REMARKS

Amendment Under 37 C.F.R. § 1.111
Serial No.: 10/759,609
Page 8 of 8

FIG.28
PRIOR ART

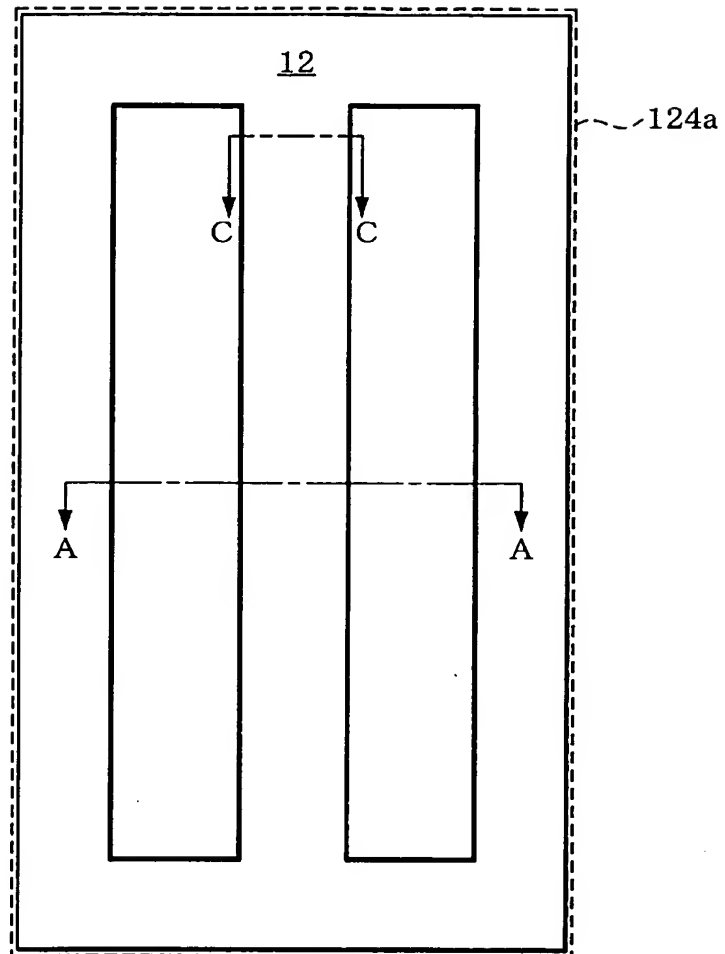
The Examiner has made a minor objection to Figures 28-34 and asserts that these figures should be labeled as "Prior Art." Applicant submits herewith a Submission of Corrected Formal Drawings for Figures 28-34 which have been labeled as "Prior Art."
